NL-04-1537

Vogtle Electric Generating Plant
Response to Request for Additional Information Regarding
Technical Specification Revision Request
DC Sources and TSTF-360, Revision 1

Vogtle Electric Generating Plant
Response to Request for Additional Information Regarding
DC Sources and TSTF-360, Revision 1

LCO 3.8.4

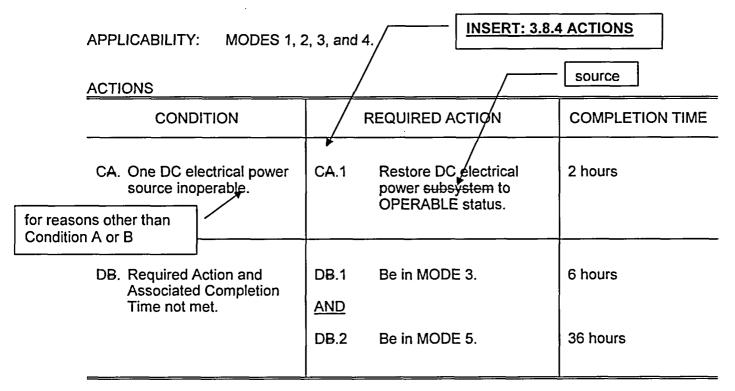
Note that the following is a new insert to replace the corresponding insert provided with our October 13, 2003 submittal. In addition, a new marked-up page 3.8.4-1 is provided along with appropriate Bases changes. Clean-typed replacements for the affected pages are also provided.

CONDITION	REQUIRED ACTION	COMPLETION TIME
A. One DC electrical power source inoperable due to inoperable battery A or B.	Enter applicable Conditions and Required Actions of LCO 3.8.1, "AC Sources – Operating," for emergency diesel generator made inoperable by inoperable battery A or B.	·
	A.1 Restore DC electrical power source to OPERABLE status	24 hours
B. One DC electrical power source inoperable due to inoperable battery C or D.	B.1 Verify SAT available AND	1 hour AND Once per 12 hours thereafter
	B.2 Restore DC electrical power source to OPERABLE status	24 hours

for reasons other than Condition A or B
